Actual Size

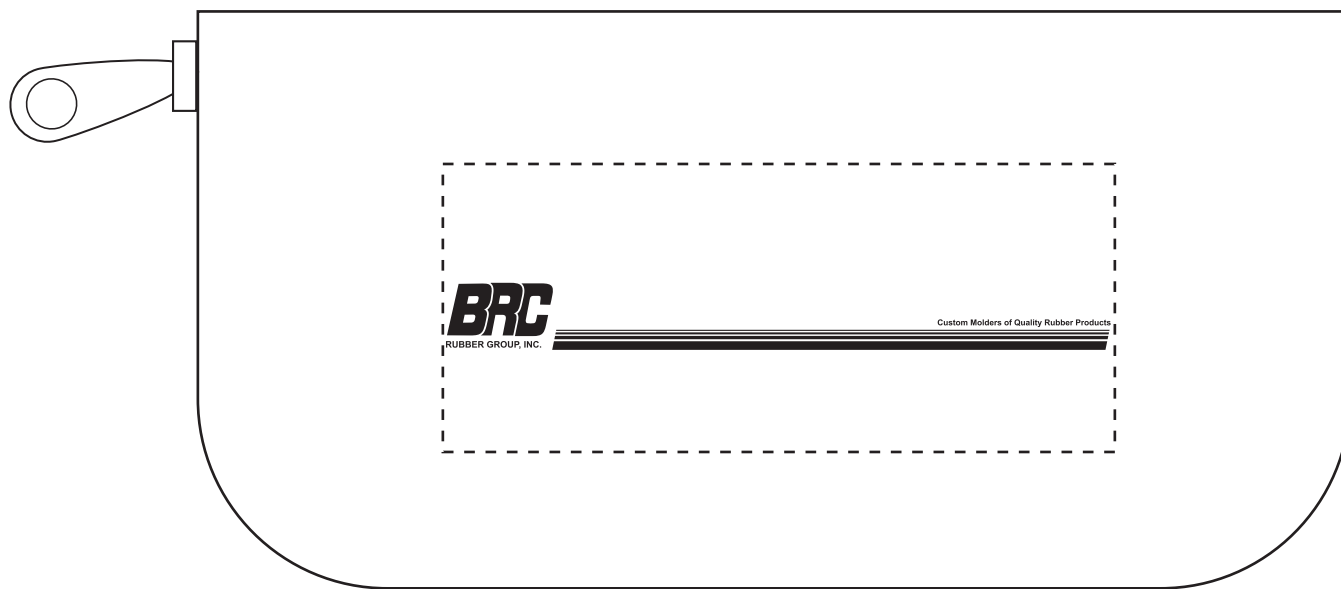
The words “Rubber Group” will fill in and may not be readable.
The words “Custom Molders... will NOT be readable.
